DATE: July 21, 2015
TO: Adam Tartakovsky, 10 SVN, LLC
FROM: Lisa Gibson, Planning Department
RE: PPA Case No. 2015-004568PPA for 10 South Van Ness Avenue

Preliminary Project Assessment

Date: July 21, 2015
Case No.: **2015-004568PPA**
Project Address: 10 South Van Ness Avenue
Block/Lot: 3506/004, 003A
Zoning: C-3-G (Downtown-General) District
Van Ness & Market Downtown Residential SUD
120-R-2 and 120/400-R-2 Height and Bulk District
Area Plan: Market and Octavia Area Plan
Project Sponsor: Adam Tartakovsky, Crescent Heights – (415) 527-9742
atartakovsky@crescentheights.com
Staff Contact: Melinda Hue – (415) 575-9041
Melinda.Hue@sfgov.org

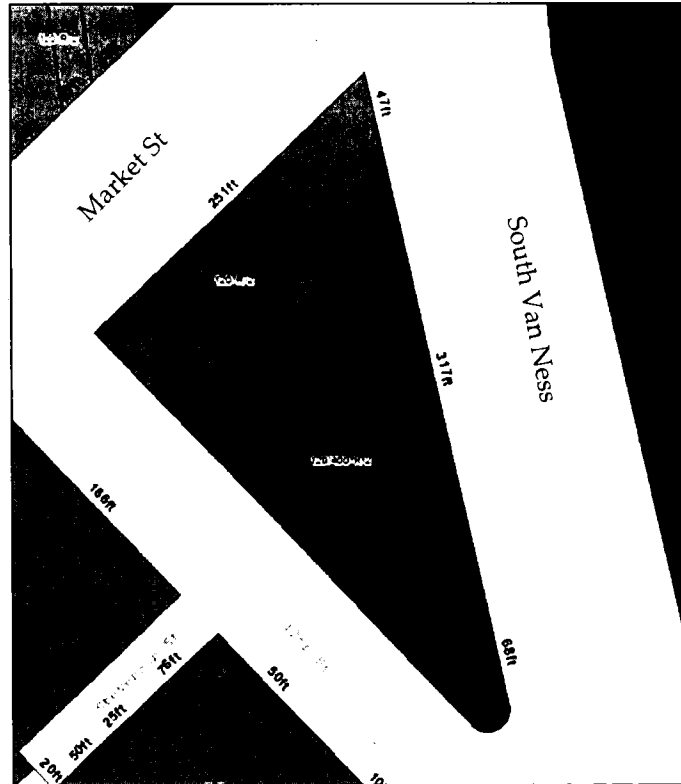
2. **Height.** Multiple Height and Bulk Districts apply to the project site. The northern portion of site is zoned 120-R-2 (with a 120' height limit), and the southern portion of the site is zoned 120-400-R-2 (120' podium height, with a tower of up to 400' in height). Portions of the northern tower are located within the 120-R-2 District, and exceed the allowable height for this District. The boundaries for the 120-R-2 District on the subject block are shown below:

In addition, the sloping parapets of both towers reach a maximum height of 440 feet, exceeding the allowances for features above the roof height limit described in Section 260(b). The project would need to be redesigned to comply with the applicable height limits, or the project sponsor would need to pursue Legislative Amendments (Height Reclassification and General Plan Amendments) in order to proceed as proposed. It should also be noted that the project does not comply with the tower separation requirements applicable to the 120-400-R-2 Height and Bulk District, as discussed below.
